## Design Response

PROJECT: 1-3 and 4, 6 and 8 Ferdinand Place London NW18EE

APPLICATION: 2016/2457/P

DOCUMENT: Phillips Planning Service (PPS) Letter ref P164917, dated 22 June 2016  
written on behalf of Mr G Parker- Whitton of no. 4 Collard Place, London in objection to this planning application

[Extract of PL 103]

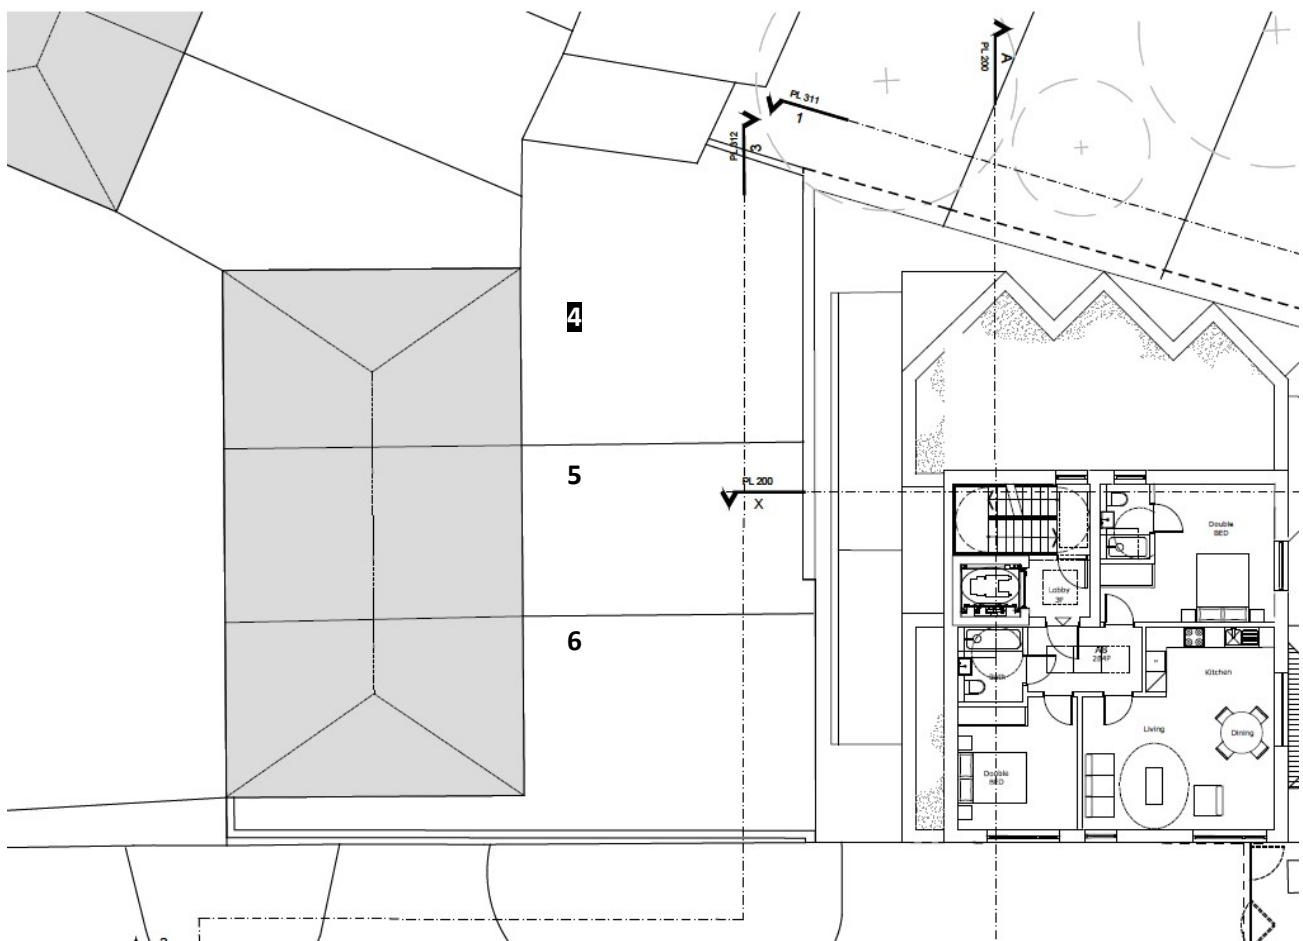
## Pages 2&3 : Quoted Distance to Boundary

The distances taken from our professionally measured survey prepared by Mobile Cad Surveying (September 2016) from the rear building line of nos. 4,5,6 Collard Place measured to the site boundary are:

4 Collard Pl.	c. 8.2m,
5 Collard Pl.	c. 8.2m
6 Collard Pl.	c. 8.5m

respectively , i.e. approximately 2 metres greater than claimed in the statement.

It should be noted that the **face of the current existing warehouse building belonging to Leverton & Sons forms the site boundary** and verification measurements can be taken directly from Collard Place to confirm the actual distance on site.

[Extract of PPS sectional diagram]

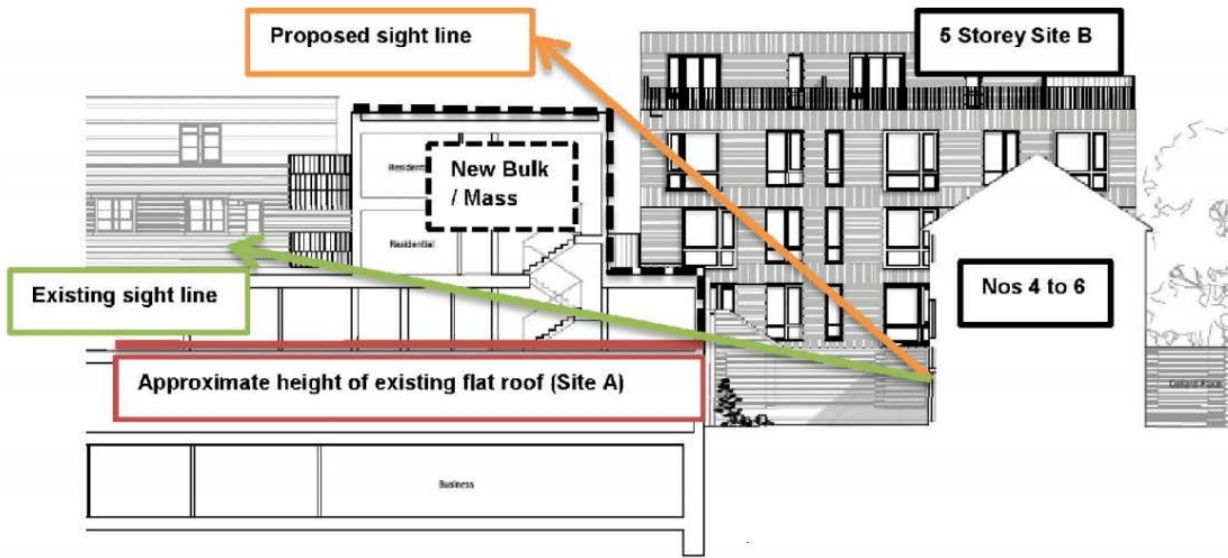
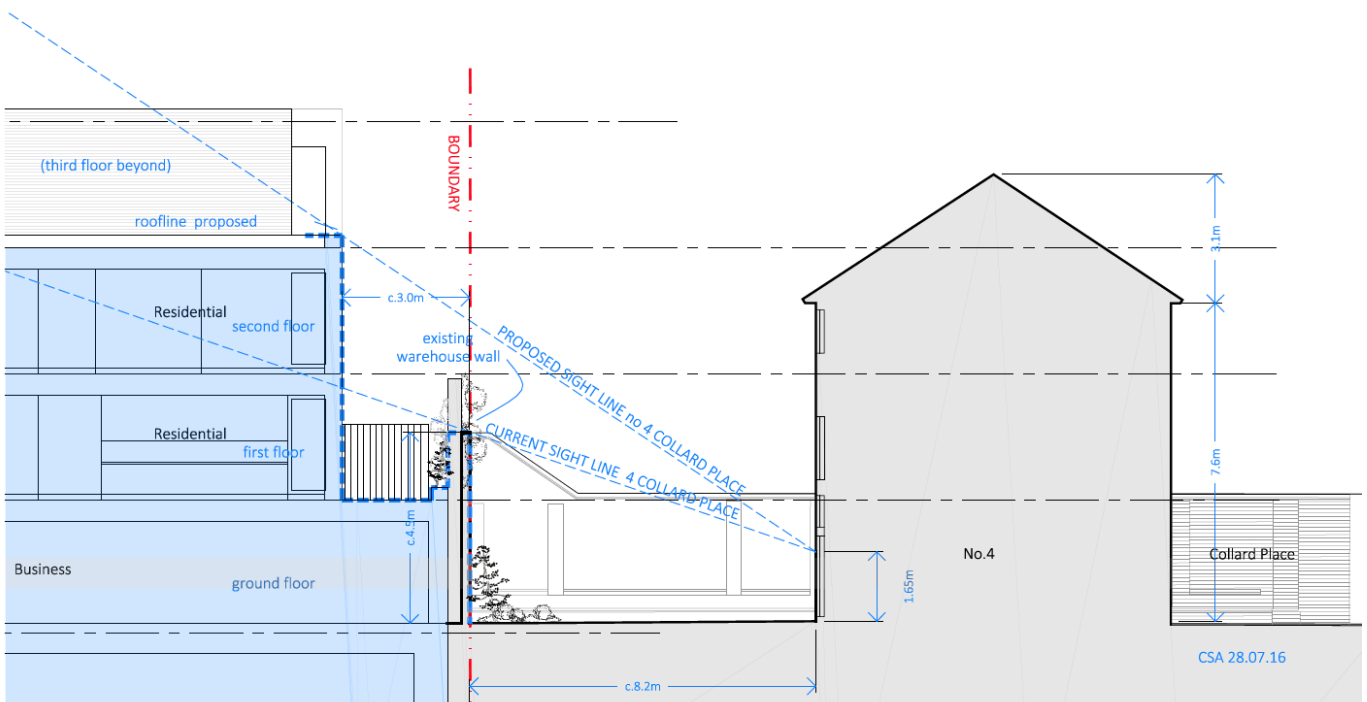
The PPS sectional diagram is incorrectly labelled "Nos. 4 to 6 " to imply a 'worst case' position also applies to number 4. There is no accommodation at first floor along the boundary as the author later points out himself on p.9 but not reflected by the applied line labelled "*New Bulk / Mass*" (black dashed).

The current warehouse roof is pitched at nos. 5&6 and significantly higher than indicated by the green 'existing sight line' arrow at no.4.

Another much steeper arrow below the yellow arrow connecting the existing warehouse gable apex to the window would need adding to correctly reflect the condition at 5&6 .

The section on which it appears to be based is actually at no.5 as indicated on our submitted plans (above).

If however, this yellow "*proposed sight line*" arrow relates to no. 4, it should not show any mass at third floor level at all as the building has been reduced in height to be lower than 4-6 Collard Place at this point (refer third floor plan PL 103) as illustrated below:

*[3D illustration of concessions made following neighbour consultation D&A Statement section 3.7]*

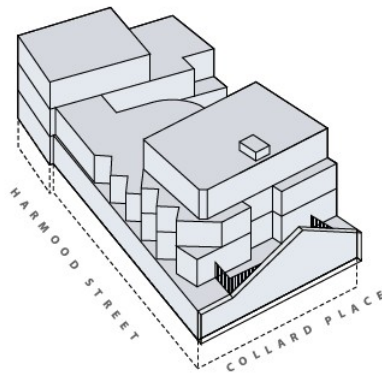
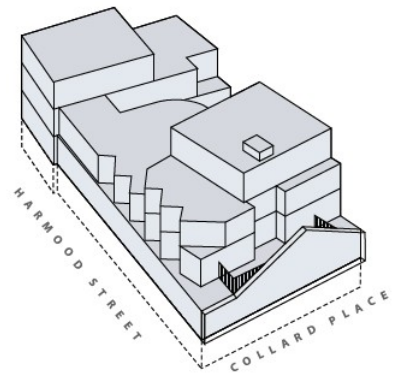
This considerable reduction in massing arose following discussion with residents of Collard Place and Harmood Street at the second public consultation in April 2016, documented and illustrated in 3D in the D&A statement section 7.8, extract below:

The "blank appearance" of the elevation facing the rear of 4-6 Collard Place was again developed in direct response to comments from Collard Place residents at the November 2015 consultation **to remove all facing windows and balconies on this elevation** ( see diagram above, D&A section 7.8).
